**Majumder Garments Ltd (9380)**

Plot #415-417, Hariarpara, Panchabati, Fatullah, Narayanganj

25.May.2014

## Identified Priority 1 Concerns

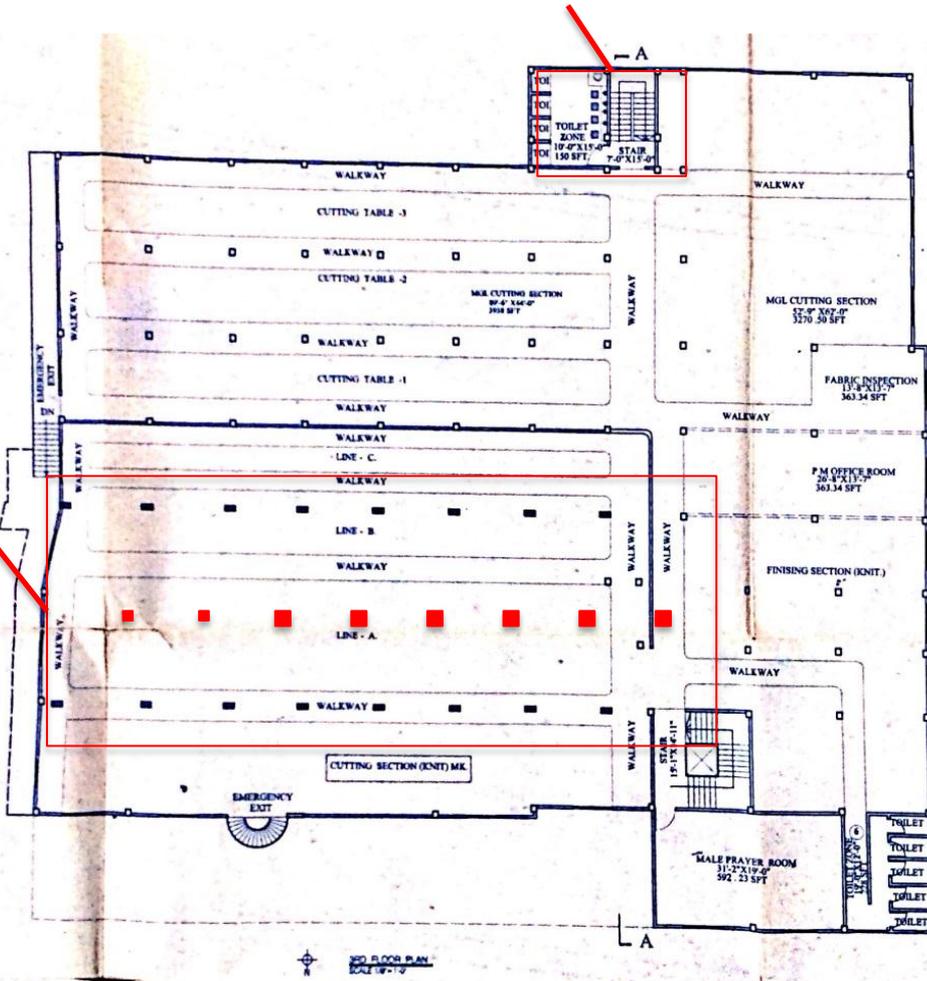
Auxiliary dormitory sheds in the courtyard are flimsy

Since the sheds house workers of the factory and are poorly constructed. They should be reinforced or strengthened to prevent them from being a danger during high winds or earthquakes.

**ITEM 3: Priority 2** - Auxiliary dormitory sheds in the courtyard are flimsy
